### Re: Narrative Response to FDP Questions and Concerns

The Project Team for STC FDP 10 has reviewed the Town and public comments received at the prior Town Board hearing. We have attempted to capture all of the discussion with additional narrative below in a question-and-answer format. Thank you for your consideration, and we look forward to continuing work with you through this transformational project.

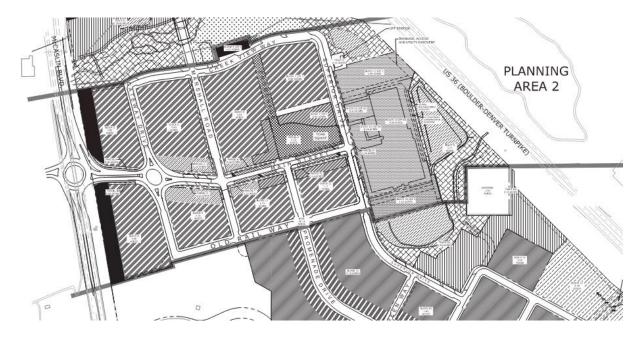
**Concern:** "It still wasn't clear to me if this building is envisioned to be populated and used by tenants round-the-clock or more aligned with standard business hours. Can you clarify? If round-the-clock, can you speak to how that could impact the surrounding community? I think I heard Bill say that this will be early stage R&D and will not include heavy weekend use, but would like to confirm.

Successful life science companies typically go through a 4-stage "life cycle", which is typically about a 10-year process:

- 1) Research (looking for a workable solution)
- 2) Development (refining and replicating the potential solution found during research)
- 3) Clinical Manufacturing (scaling up production for clinical trials)
- 4) Commercial Manufacturing (large scale commercial production and distribution, typically in a separate GMP facility.)

Coal Creek Innovation Park is designed to support the early stages of this life cycle, namely the Research and Development phases, which are not focused on heavy manufacturing or production. Clinical and Commercial manufacturing generally require even larger clear heights, energy and water requirements than will be supported in these buildings. While Applicant would not support any condition that limits the use of private property to certain
